# TDECQ and SRS

Piers Dawe

# 1-dimensional TDECQ is only part of what we need. SRS tweaks can follow

# TDECQ map and Rx specs

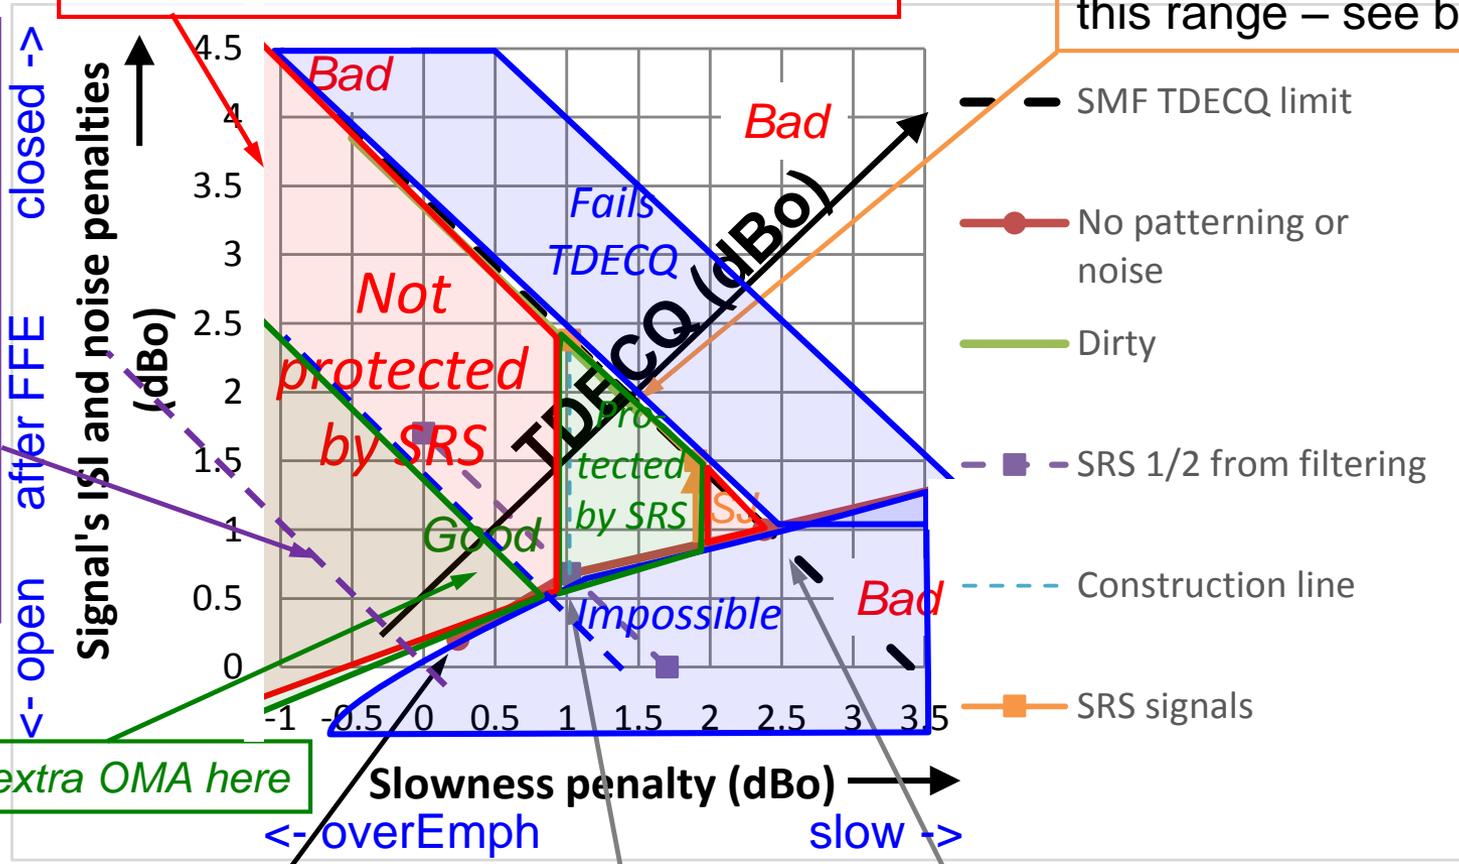
There's no limit on the left in the draft

The "other" receiver sensitivity is defined up to the max for TDECQ, with min. zero, which seems too low

Transmitted signals are allowed that receivers don't have to receive (red regions)

# Mismatch between SRS and real signals?

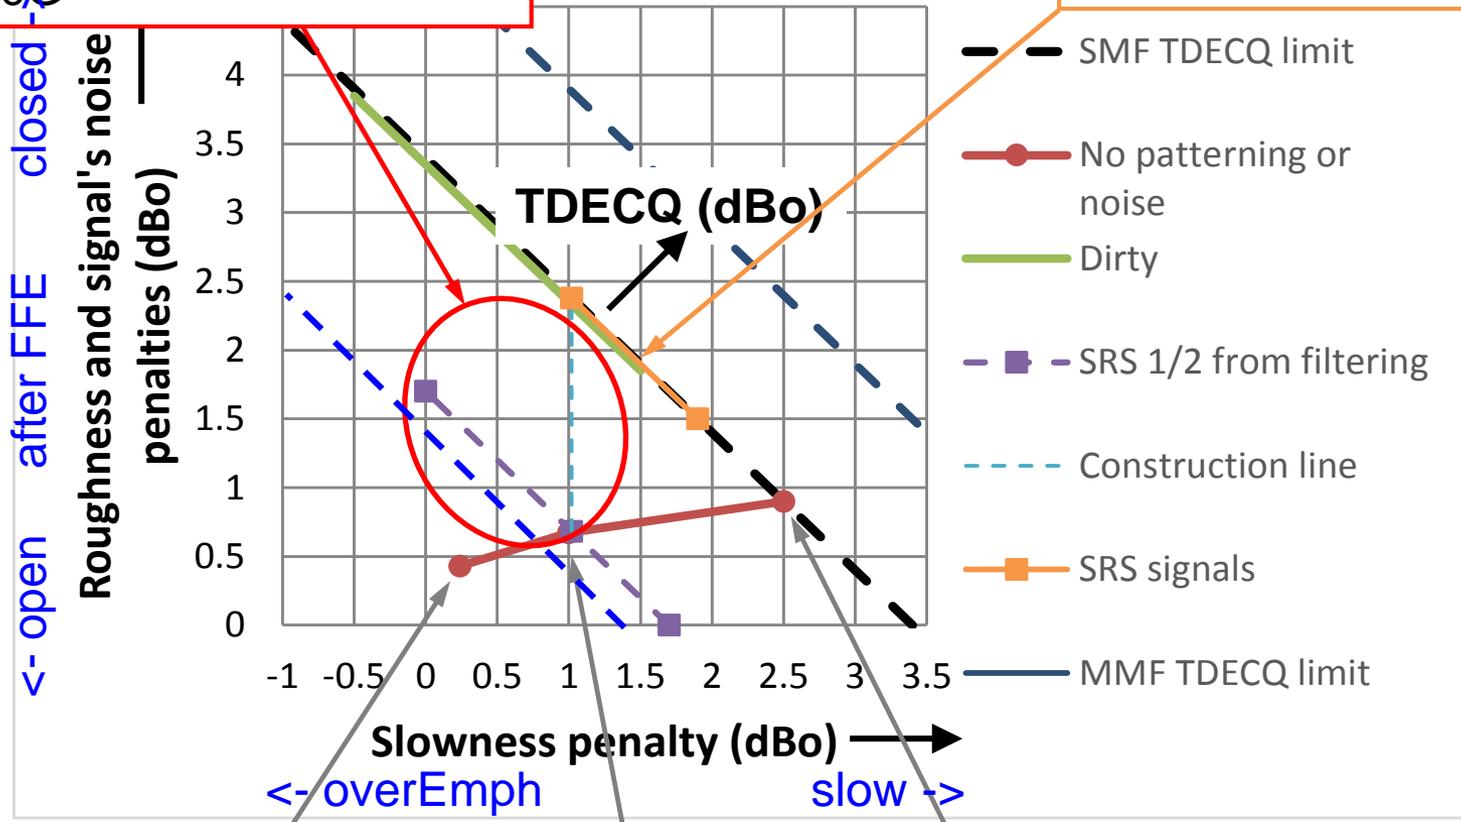
Where will real poor signals be? Here? 50G can be better than 100G

# Real signals, from an anonymous survey

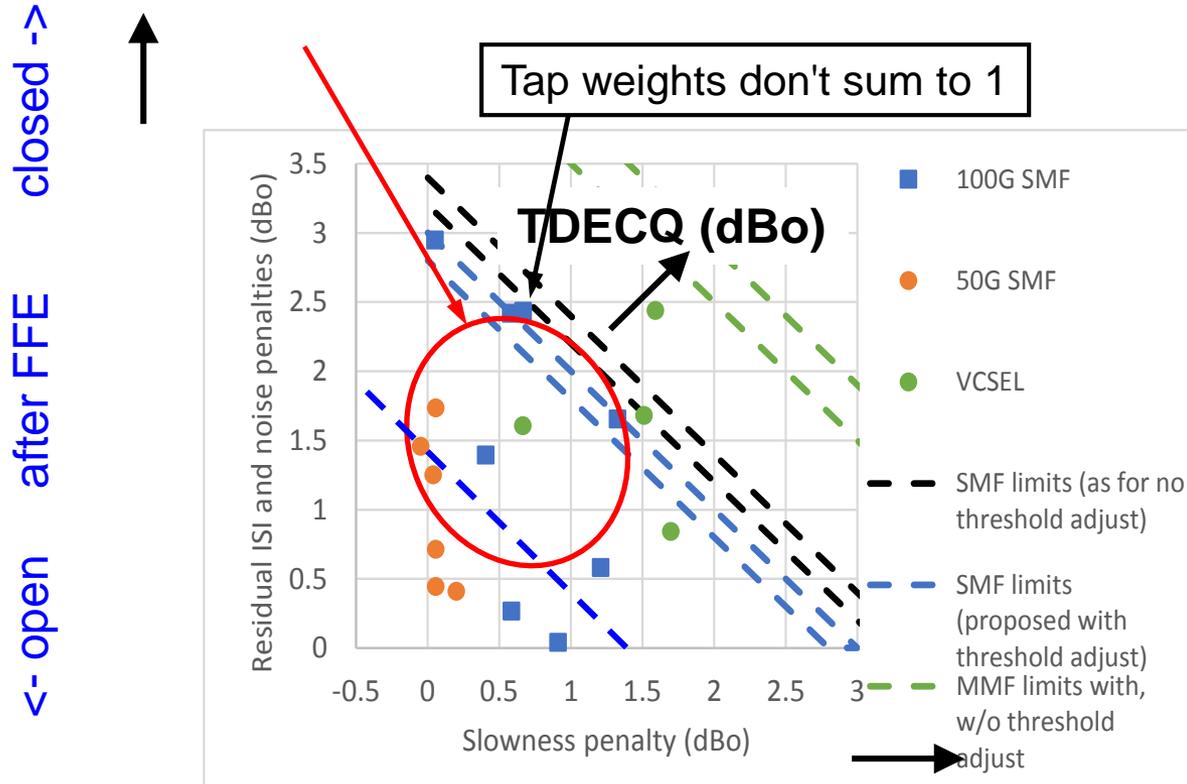
- Transmitters include EML, SiP, one MZM, VCSELS
    - One high-TDECQ point has a data error?
  - The red ellipse is a compromise between 50G and 100G, SMF
  - The 50G signals have TDECQ well below the TDECQ limits
  - All 50G SMF signals are far to the left of the slowest allowed
  - Many SMF transmitters seem to be using emphasis – some want to be on the left of zero
- See later for more, inc. Rx tap coefficients*

# Don't support unrealistic bad scenarios

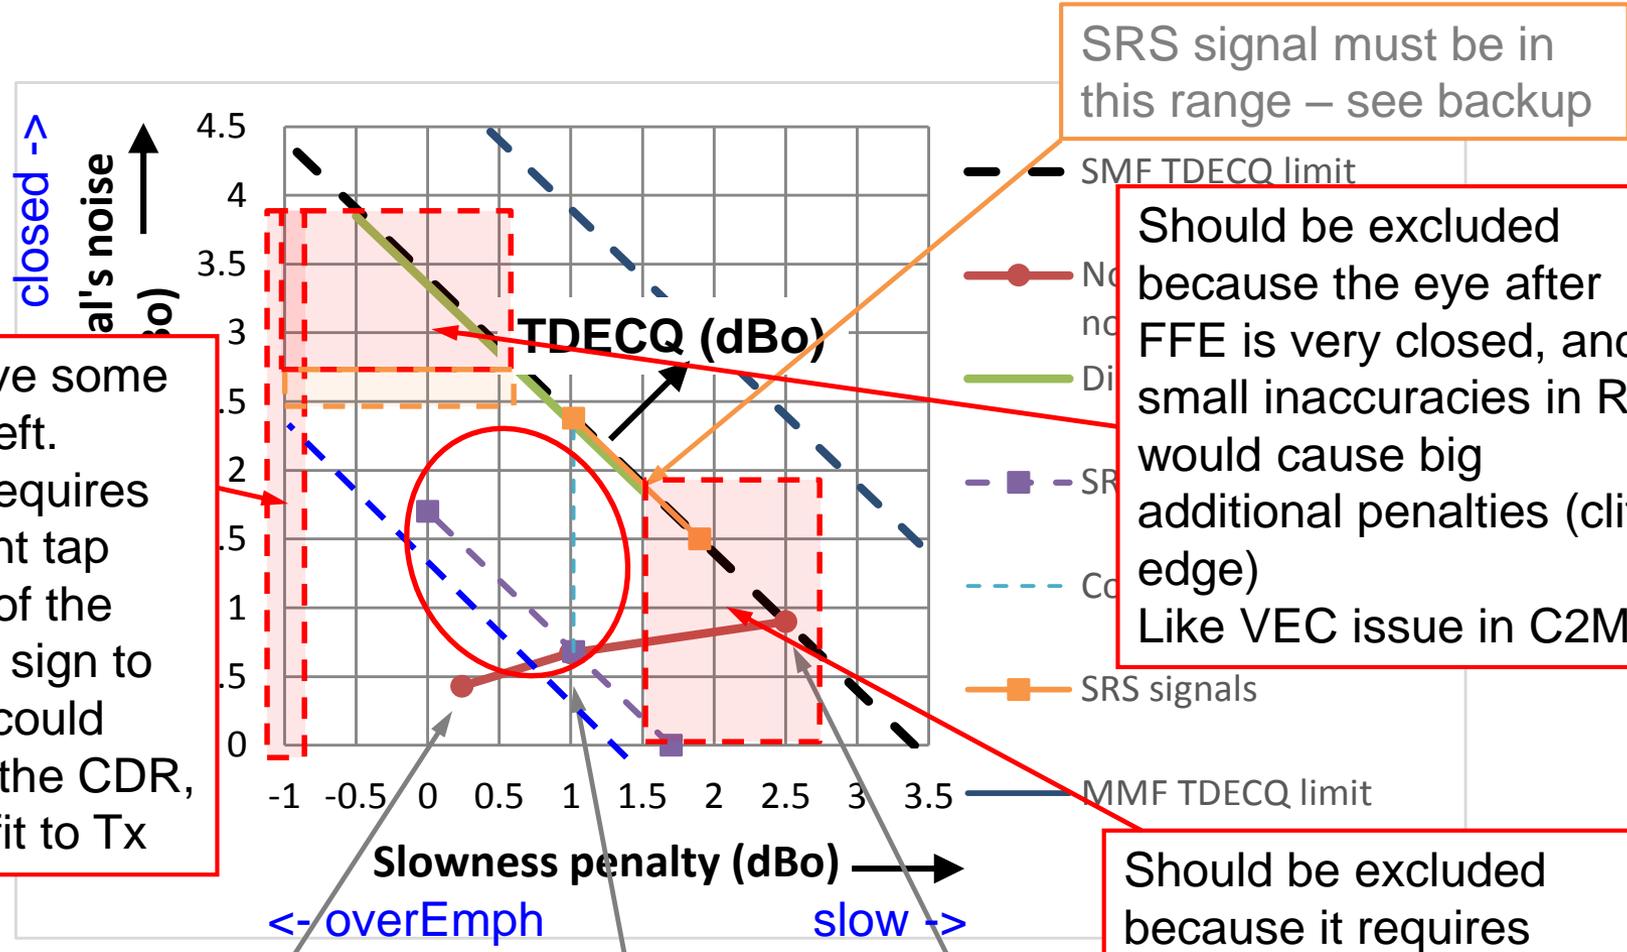
Must have some limit on left. Too far requires significant tap weights of the opposite sign to normal, could confuse the CDR, no benefit to Tx

Should be excluded because the eye after FFE is very closed, and small inaccuracies in Rx would cause big additional penalties (cliff edge) Like VEC issue in C2M

Should be excluded because it requires strong tap weights not useful in practice, for SMF would have failed T/2-spaced TDECQ

"Exclusion" could be by giving signals in the red boxes worse TDECQ scores, or by "hard" pass-fail rules

# Possible peak/OMA and risetime specs

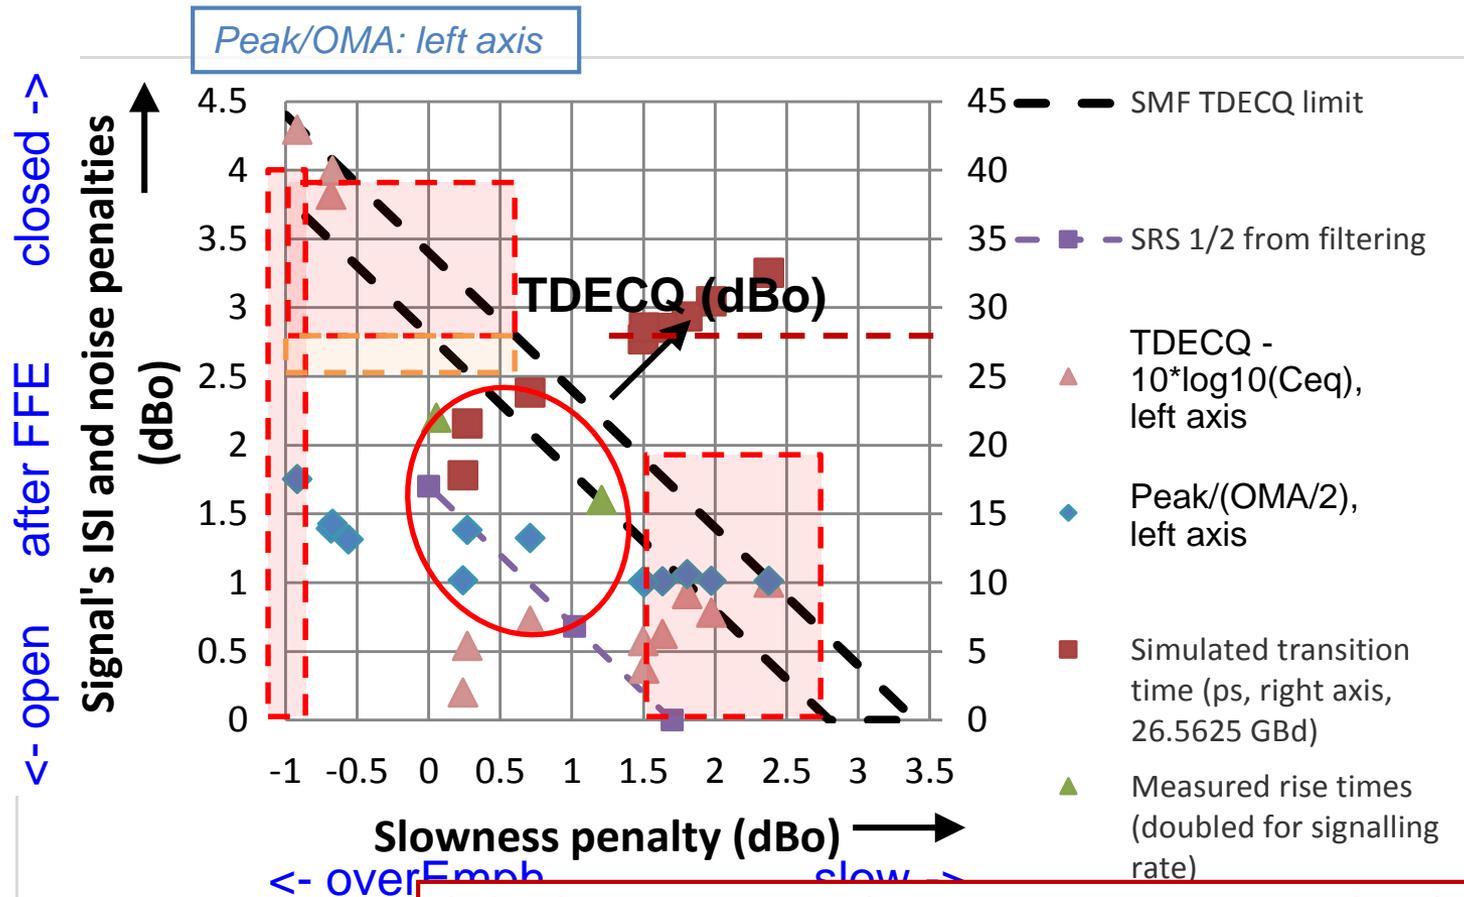
A peak/OMA spec would exclude signals that have too much "dynamic range", but does not seem to control over-emphasis unless very bad

A risetime spec around 30 ps seems to screen signals that are slower than allowed for PAM2  
 Limit for 50G lanes should be a bit tighter than that: propose 27 to 28 ps if no tap limit  
 This is 20-80% observed in the usual fb/2 BW  
 Scatter needs more investigation, but promising for right side, not so for left side

# Possible largest tap spec

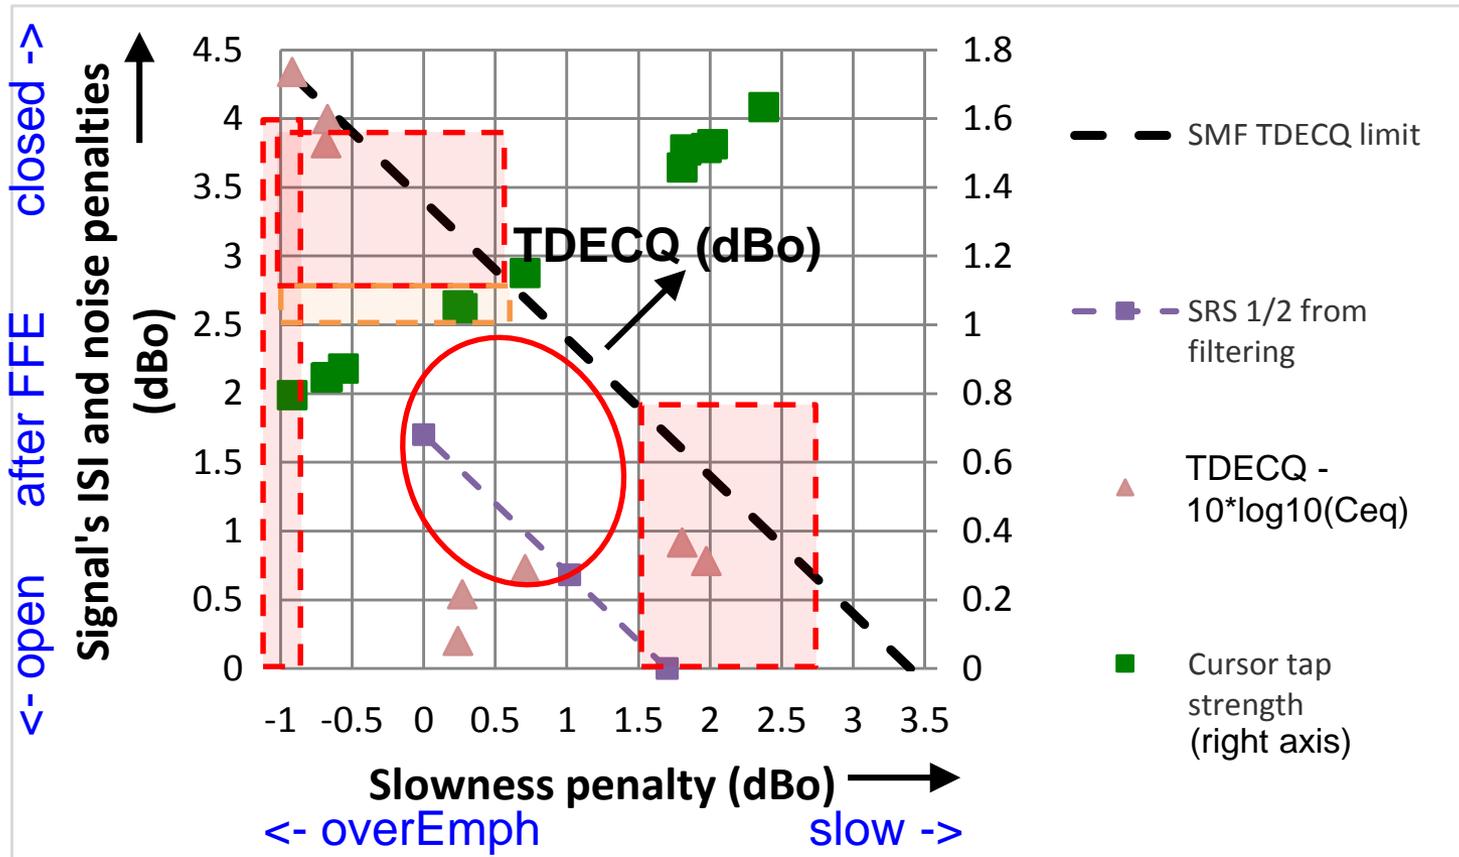
- So far, the correlation between slowness penalty in dB and largest tap coefficient looks promising
- This might be just luck
- This is a simplification of a previous proposal that used the sum of the other four taps

# Extremes of worst-case signals

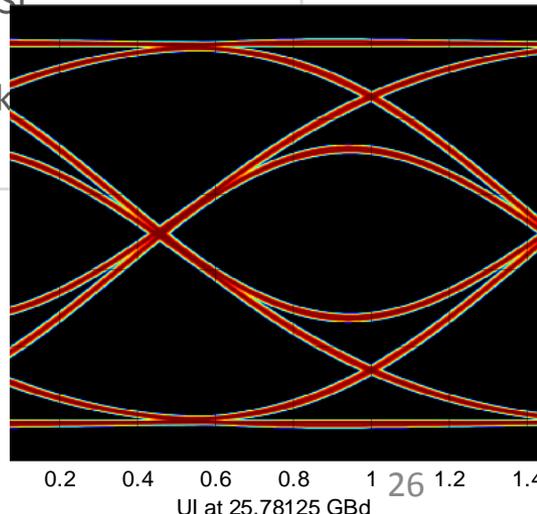
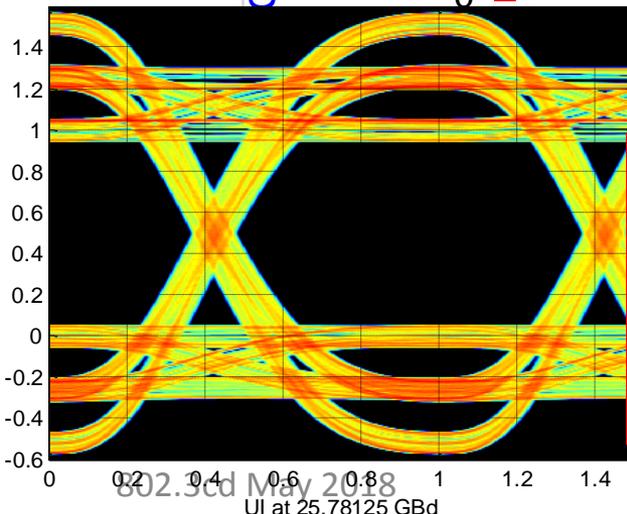
The signal on the left is bad because nothing can be done to improve it – neither sensitivity nor EQ.  
 Worse is allowed by the draft
